Planning Commission Regular Meeting

Tuesday, May 19, 2026, 6:30 PM
106 Center Street

To: Planning Commission

Excelsior Good Neighbor Guidelines PLAN Review

PROPOSED SITE PLAN
SCALE: 1"=20'

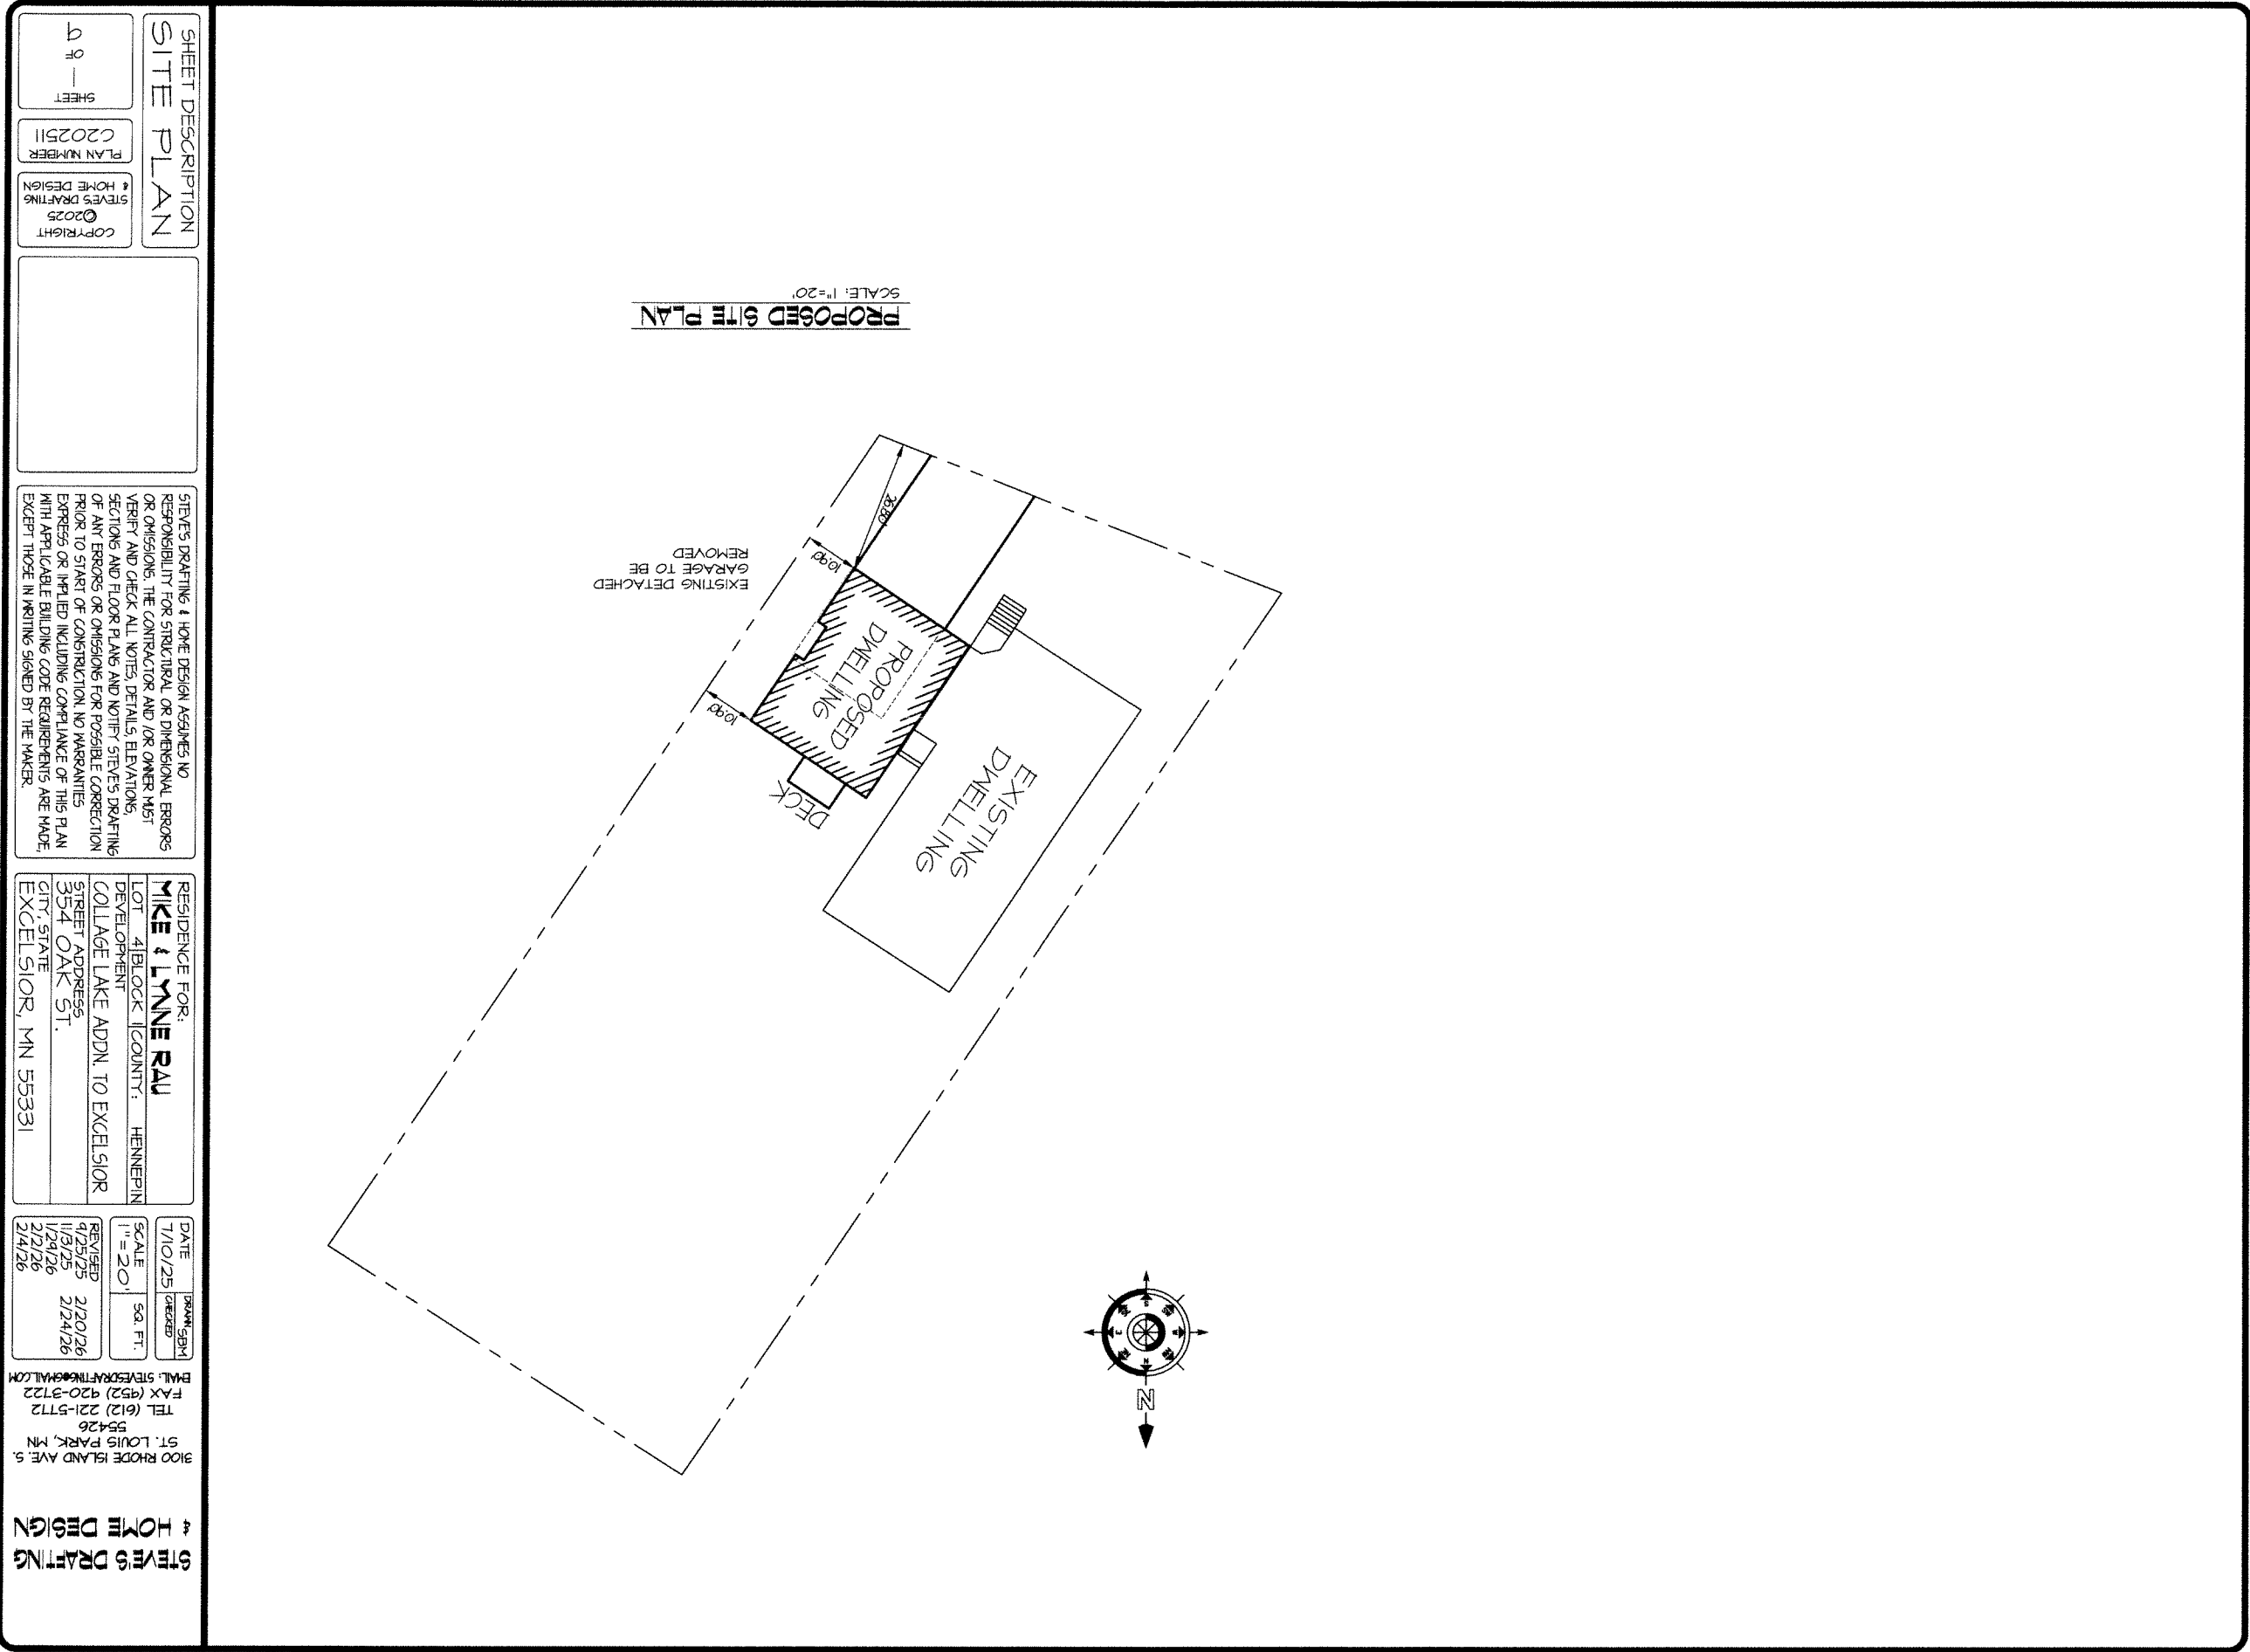
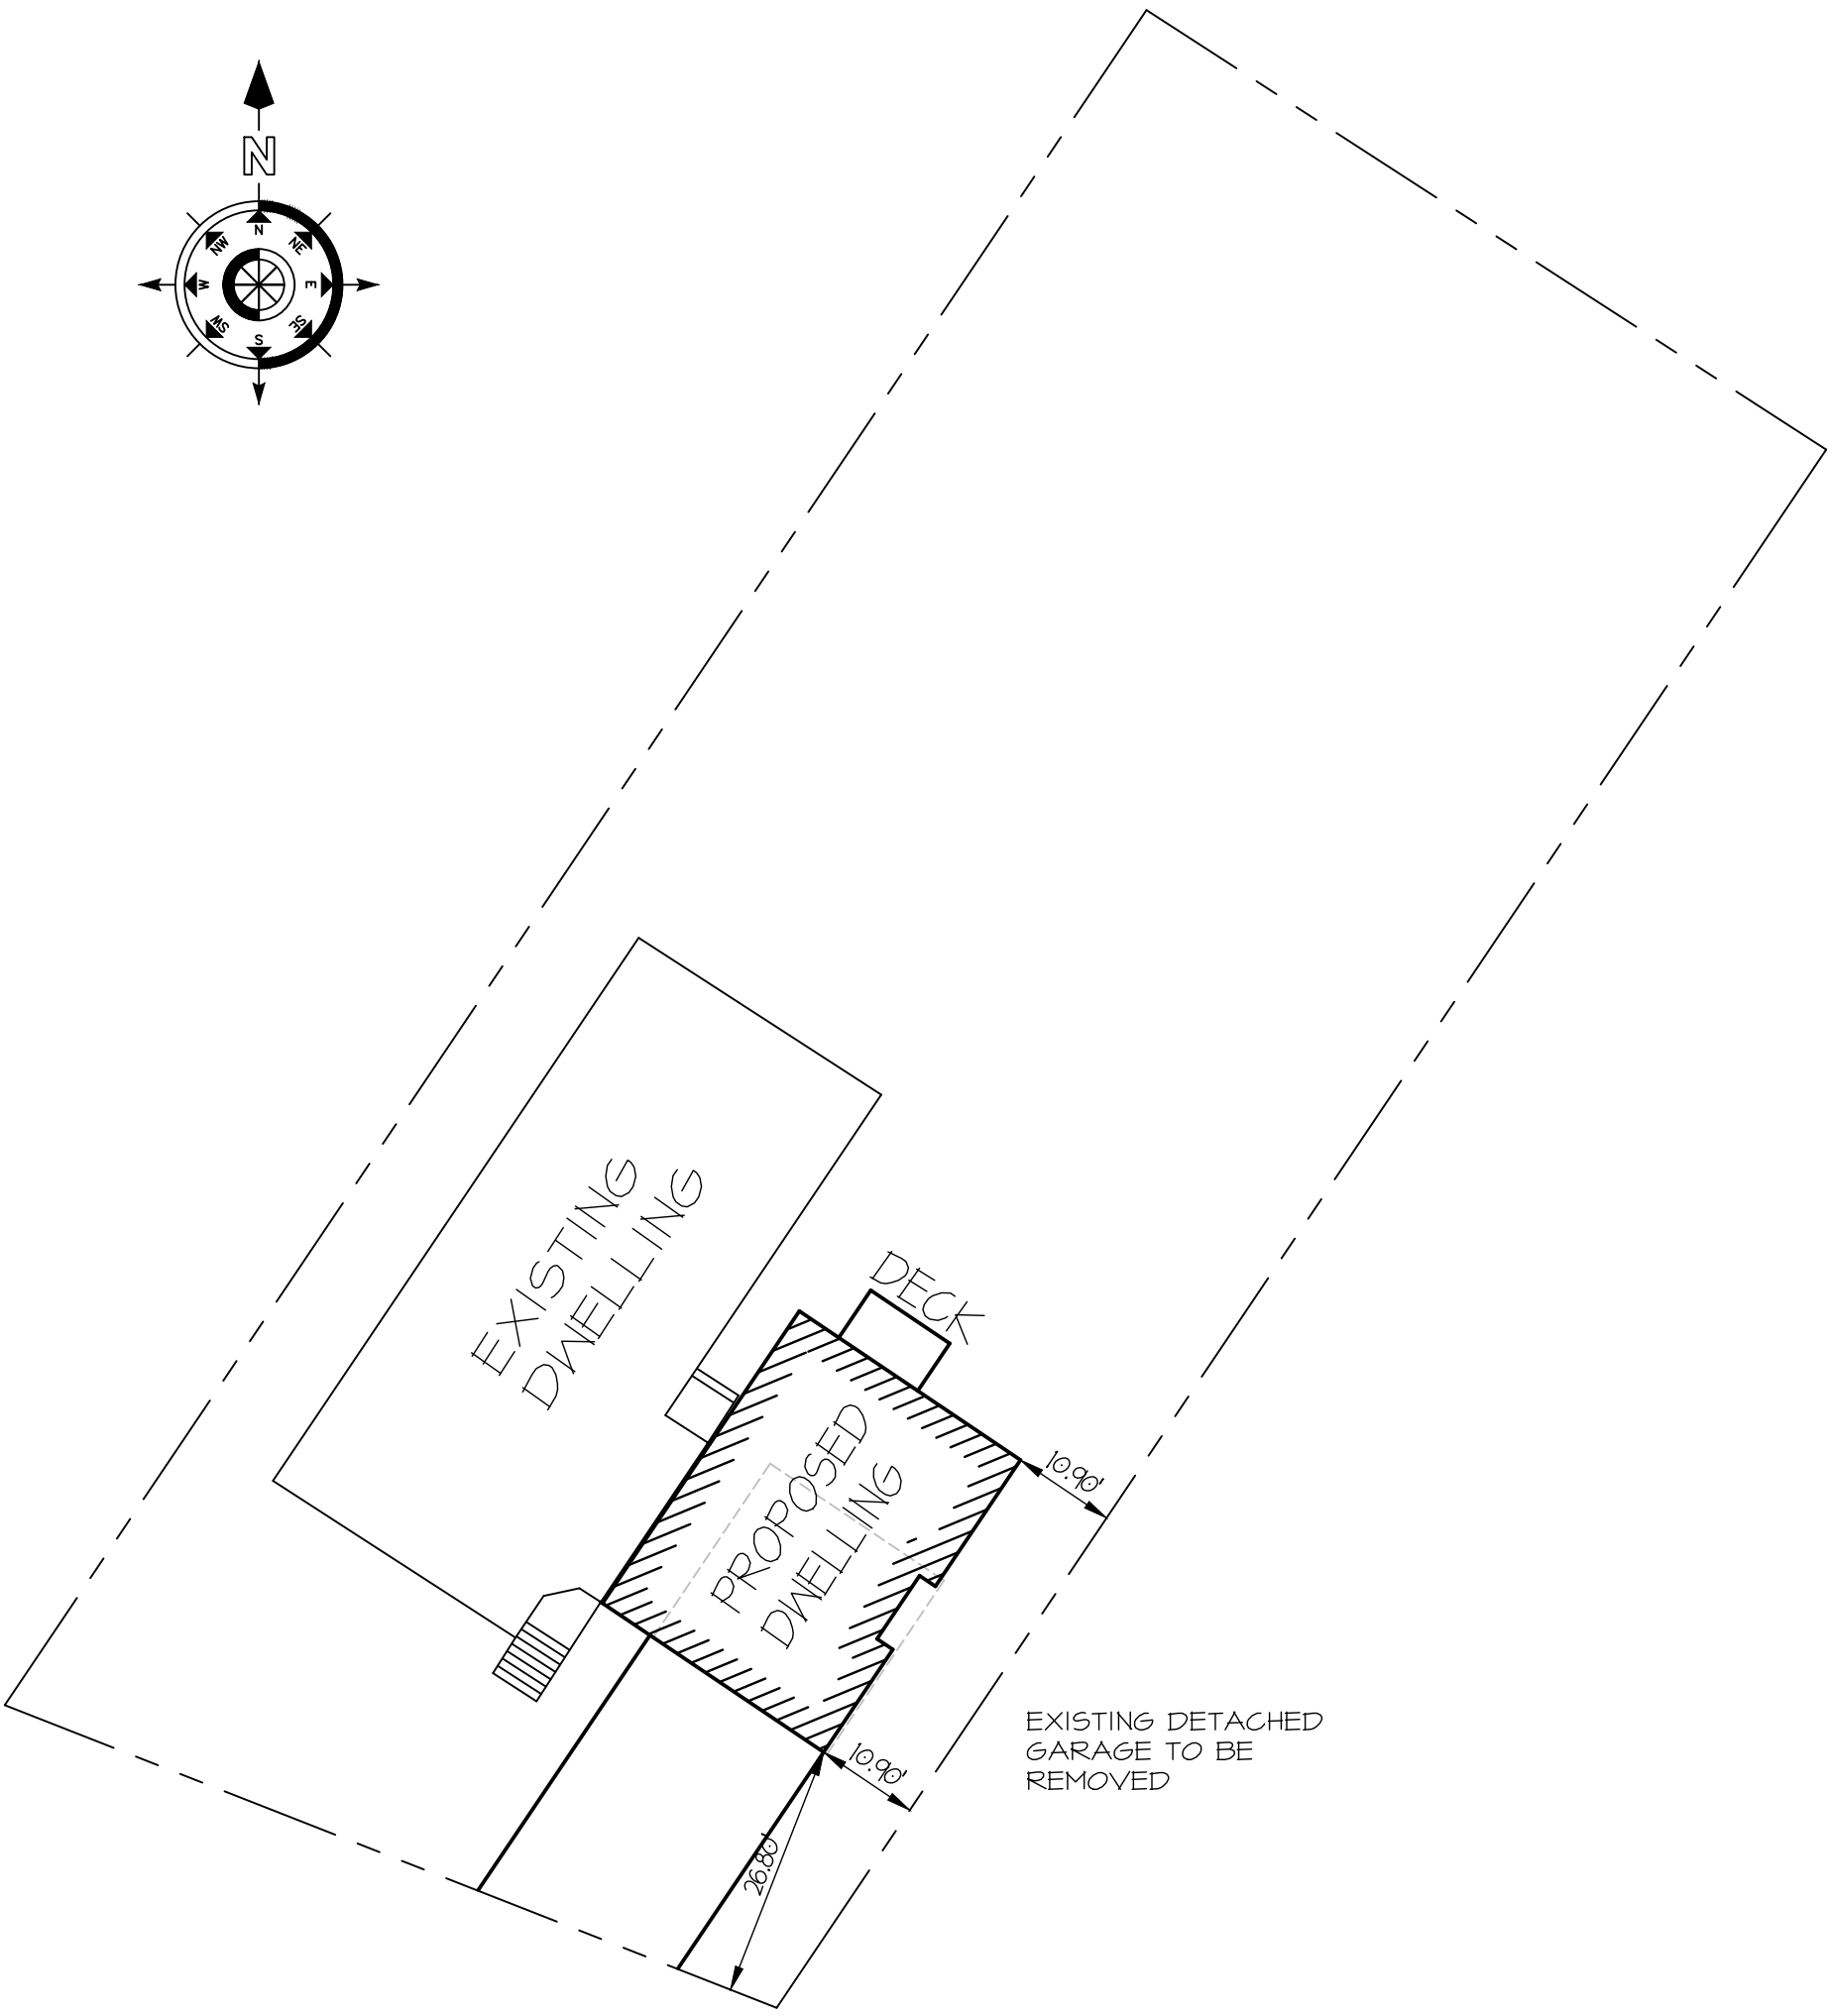
The new structure is responsive to existing grades and elevations, and no new retaining wall are indicated. Except for indicated driveway, the Site plan/survey is unclear on site paving, sidewalks or proposed planting.
